**DRAFT PROPOSED CODE CHANGES
FOR
THE CALIFORNIA BUILDING CODE
CALIFORNIA CODE OF REGULATIONS, TITLE 24, PART 2**

**2016 CALIFORNIA BUILDING CODE
TRIENNIAL CODE CYCLE**

**CHAPTER 11B
ACCESSIBILITY TO PUBLIC BUILDINGS,
PUBLIC ACCOMMODATIONS, COMMERCIAL BUILDINGS AND PUBLICLY FUNDED HOUSING**

FIGURE 11B-703.7.2.6.4
EDGES AND VERTICES ON GEOMETRIC SYMBOLS

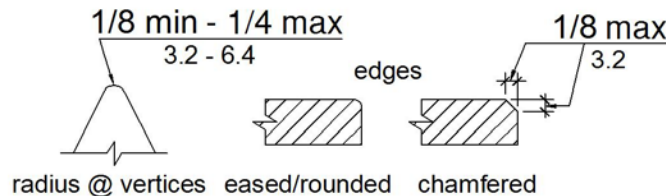
11B-703.7.2.6.4 Edges and vertices on geometric symbols. *Edges shall be eased or rounded at 1/16 inch (1.59 mm) minimum, or chamfered at 1/8 inch (3.2 mm) maximum. Vertices shall be radiused between 1/8 inch (3.2 mm) minimum and 1/4 inch (6.4 mm) maximum.*

REASON: DSA-AC is proposing to amend these existing sections and add a new section to clarify the technical requirements for geometric symbols located at the entrances to toilet and bathing facilities. DSA is proposing to add dimensional specificity to Sections 11B-703.7.2.6.1, 11B-703.7.2.6.2 and 11B-703.7.2.6.3 to provide greater consistency in the manufacture of the symbols. New Section 11B-703.7.2.6.4 will provide dimensions for eased, rounded or chamfered

edges on all symbols and dimensions for the radius at vertices on triangles. The addition of a figure illustrating the requirements of Section 11B-703.7.2.6.4 will provide clarity and consistency for code users.

FIGURE 11B-812.9
SURFACE MARKING

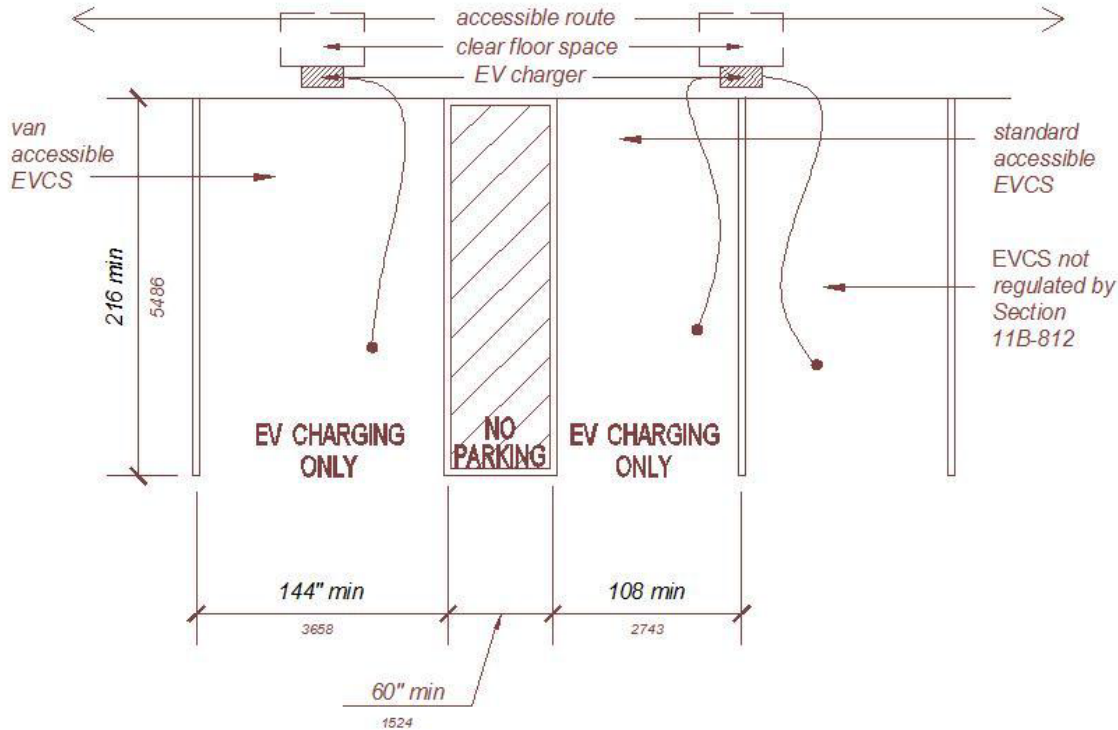
11B-812.9 Surface marking. *EVCS vehicle spaces shall provide surface marking stating “EV CHARGING ONLY” in letters 12 inches (305 mm) high minimum. The centerline of the text shall be a maximum of 6 inches (152 mm) from the centerline of the vehicle space and its lower corner at, or lower side aligned with, the end of the parking space length.*
